**Subject** Building Addition Plan Review

Re: City of Napoleon  
Cloverleaf Cold Storage  
Freezer and Office Addition  
Plan Review

*To: Brent N. Damman - Zoning Administrator*  
*From: Adam C. Hoff, P.E. - City Engineer* **ACH**  
*cc: Mike Heiss, Jeff Marihugh, Rex Moll*  
*Date: June 3, 1998*  
*Subject: Cloverleaf Cold Storage Plan Review*

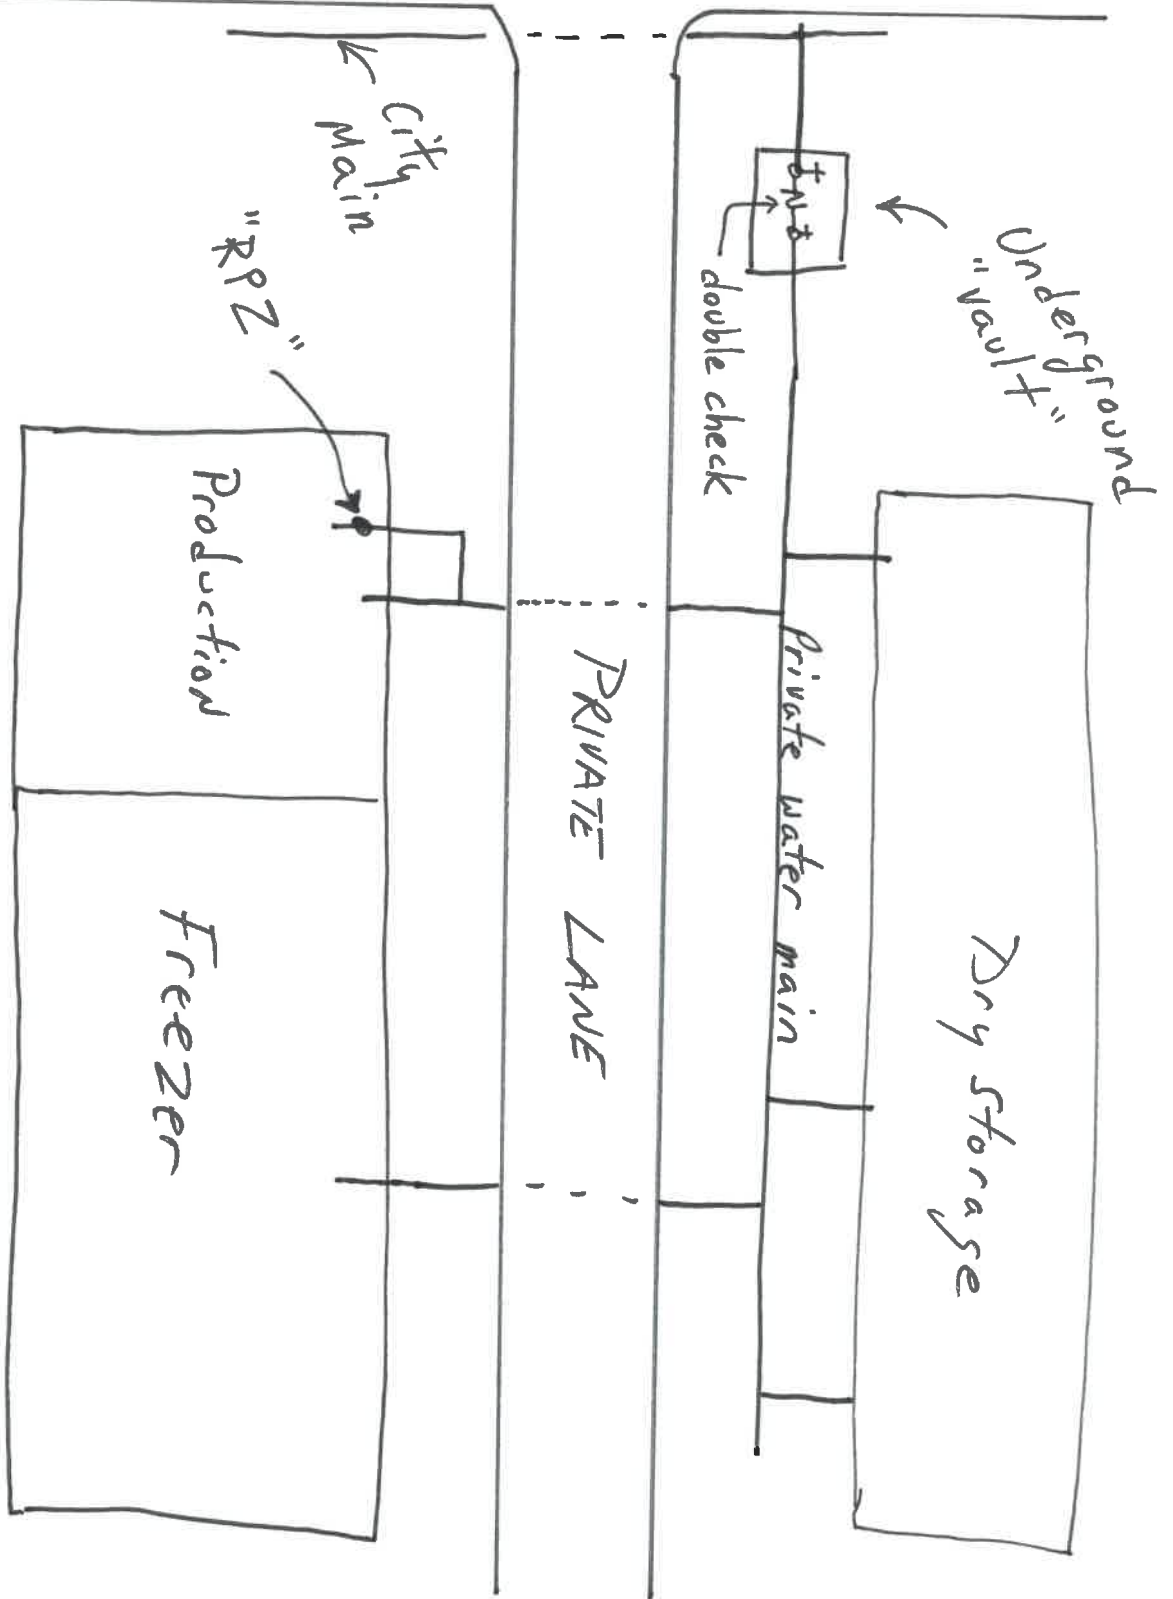
The advantages are threefold for us. First, we avoid the cost of building and heating an above-ground enclosure. Second, the enclosure, while not unsightly, would nonetheless be unattractive. Third, the enclosure above ground might impair drivers visibility at the intersection of our road with Independence Avenue.

I understand that the installation I am suggesting is not typical, but it should prove functionally adequate to reach the ends desired by state and federal law. Placing the RPZ as I indicate will also protect our other water supplies at the site, which an installation at the road intersection will not do.

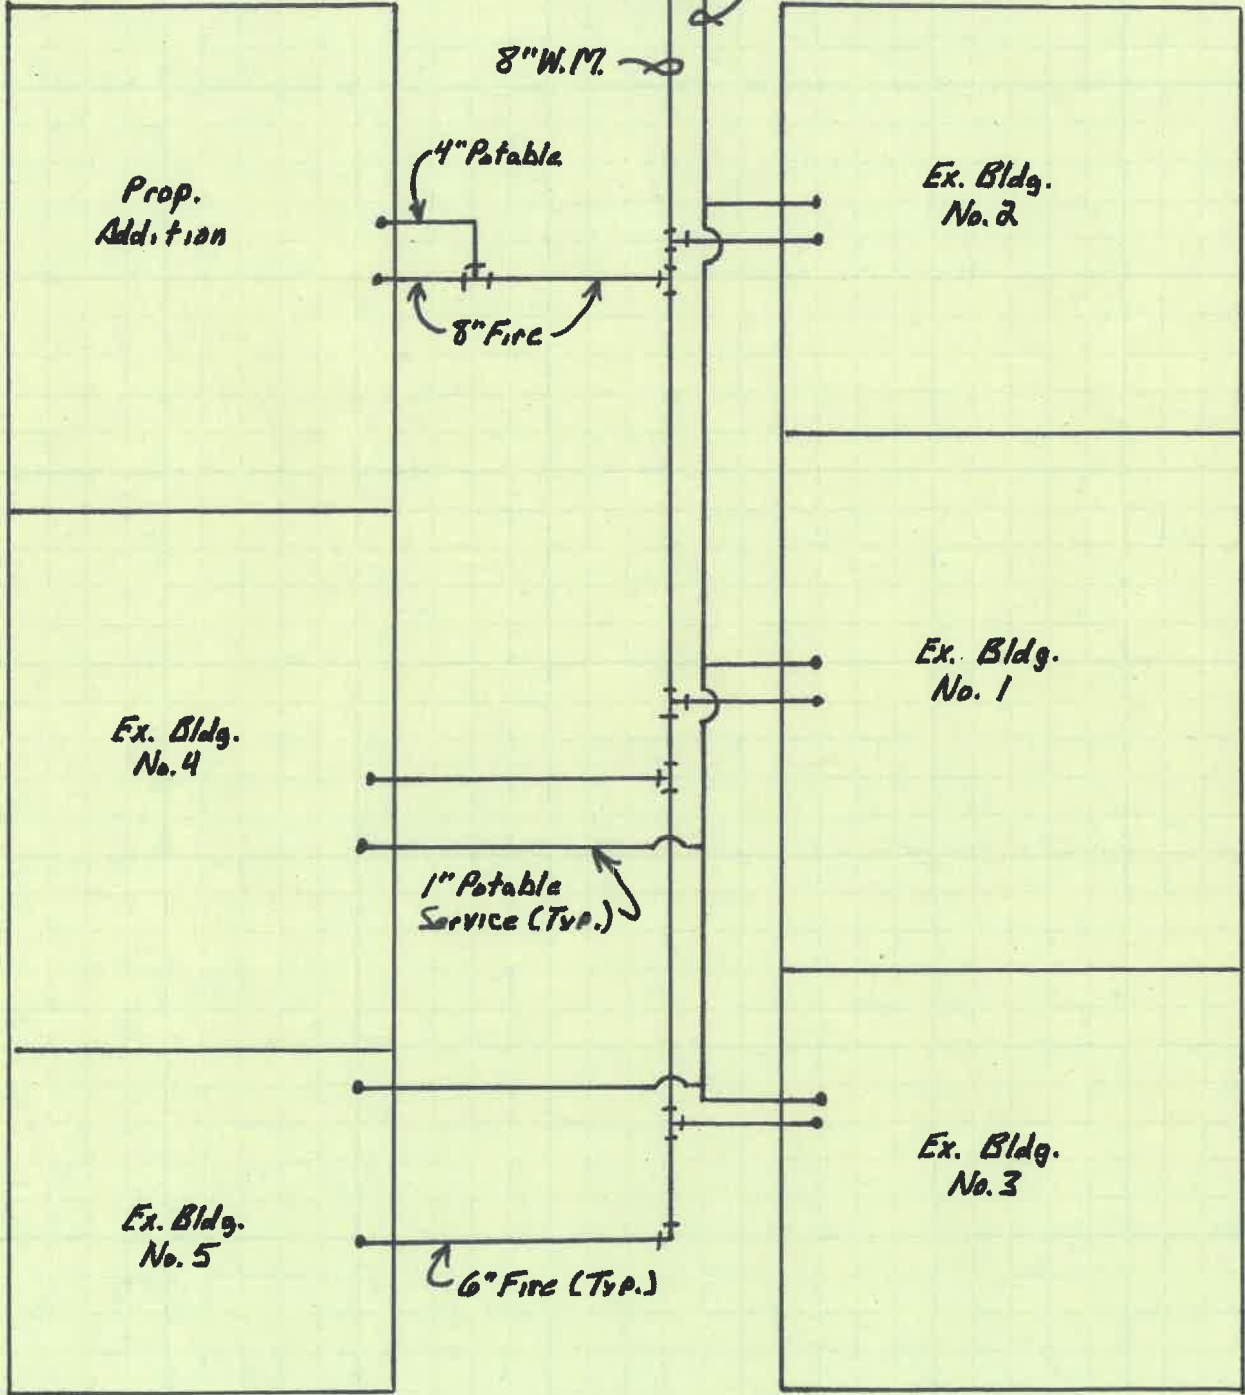
In our review of the plans for the proposed addition, we allowed the construction of a new 8" fire line off of the existing water main with a 4" potable water connection from that new fire line. We further required that the owner provide a dual detector check valve on the new fire line and a reduced pressure backflow prevention device (RP) on the 4" potable water supply. Finally, we also put the owner on notice that they will need to upgrade their entire facility to meet current fire and backflow prevention codes.

The final item is where the concerns were raised. Because the facility has five (5) other buildings, each with their own fire and potable water connections, upgrading the existing buildings will be a very costly venture. In order to reduce the anticipated costs, it was suggested that the piping within the valve vault be modified such that the backflow requirement for the entire site would be provided at one (1) point versus upgrading all of the connections.

My basic question is this, if a sufficient backflow device is provided within the valve vault for the entire site, would it be acceptable for a private fire line to serve as the potable water supply also? Please review this issue and let me know your recommendations.

PIT DETAIL  
SCALE 1/4" = 1'-0"

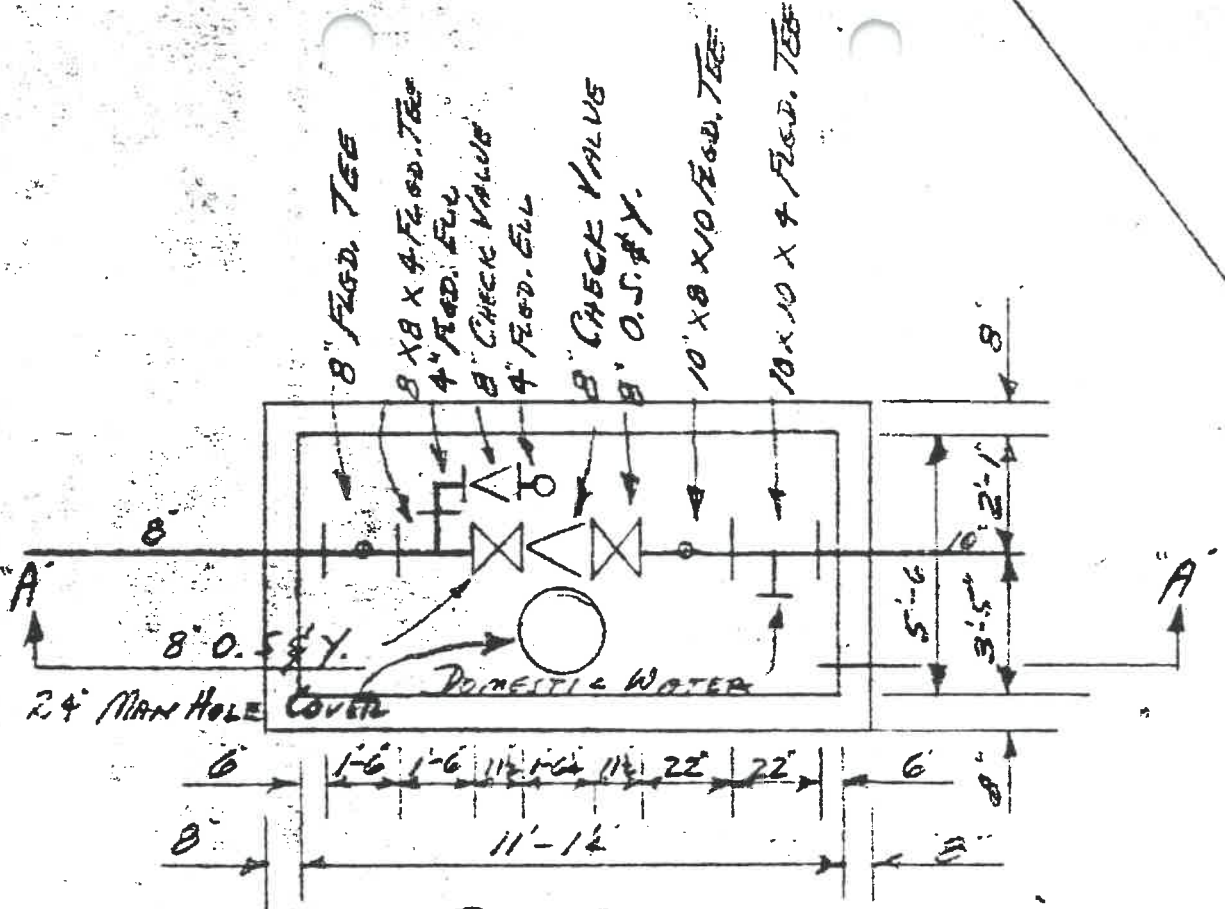
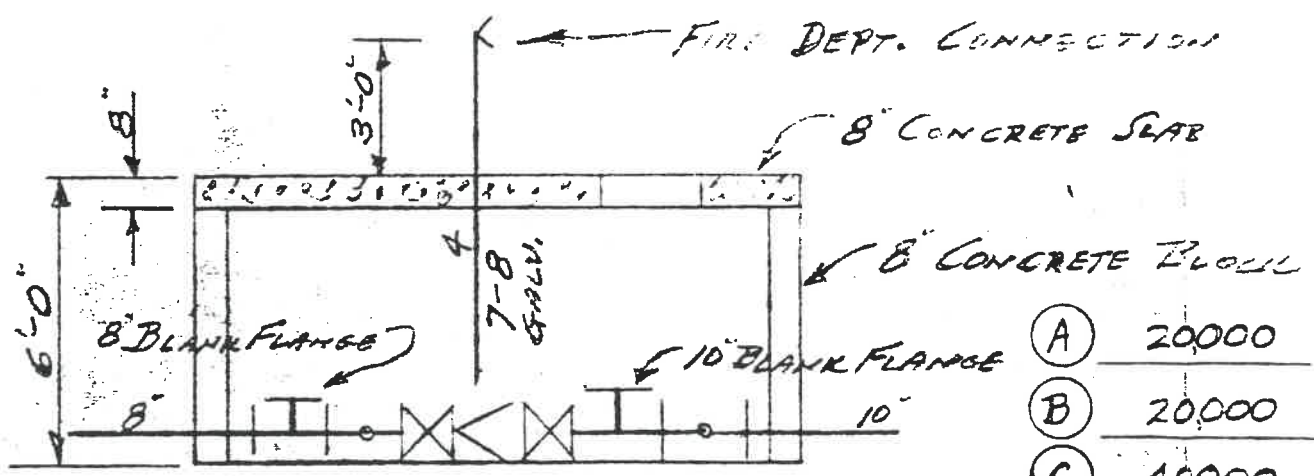
Based upon Staff review of the plans submitted for the referenced project, we have several concerns and comments which must be addressed as part of the additions. The existing eight (8) inch water main feeding the facility from Independence Drive (formerly Industrial E/W) was installed in 1974 when the first warehouse facility was constructed. As part of the installation of the original main, a valve vault, including a siamese connection to boost the fire suppression system, was also constructed. A copy of the drawing of this valve vault is enclosed.

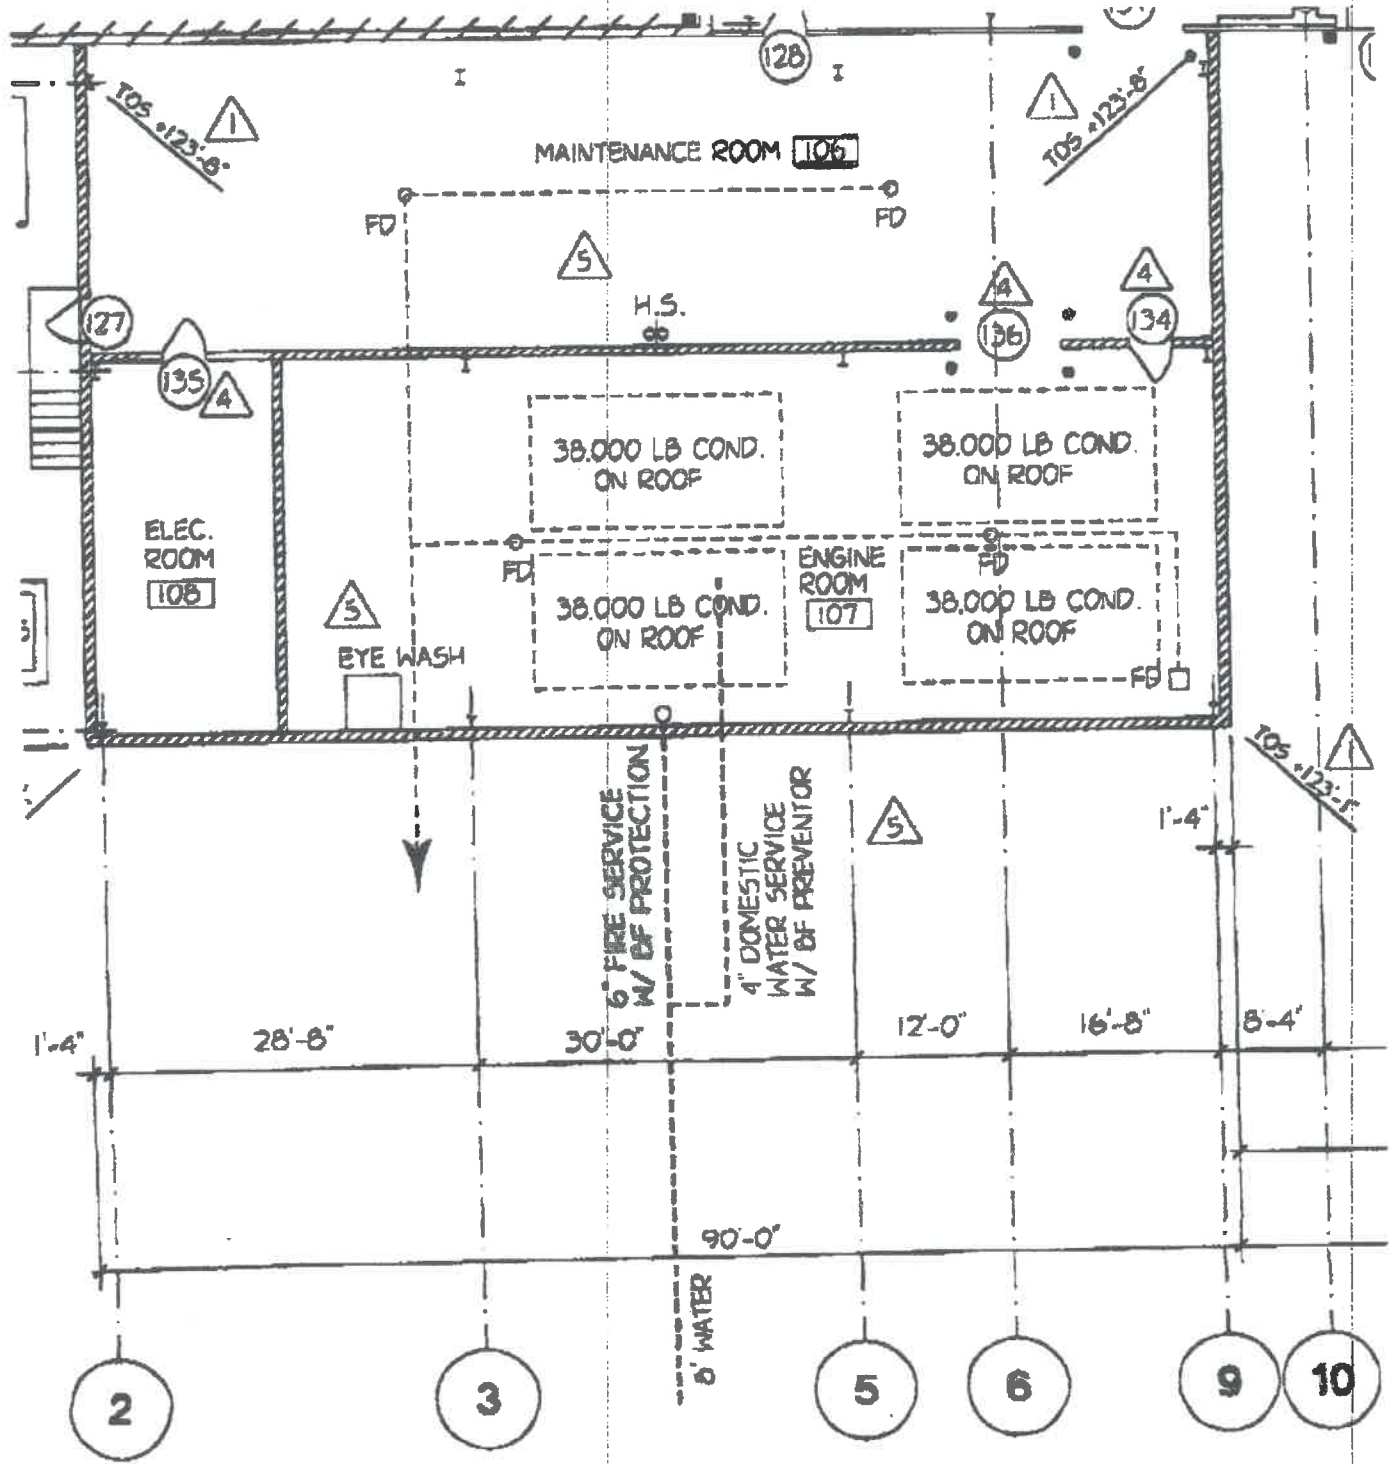
B.) 4" domestic to Independence, upgrade ex. siamese conn., install master meter + BF prevention, existing main becomes private and is maintained as such

6.) Ohio building code 916.2 requires one (1) siamese connection for entire building
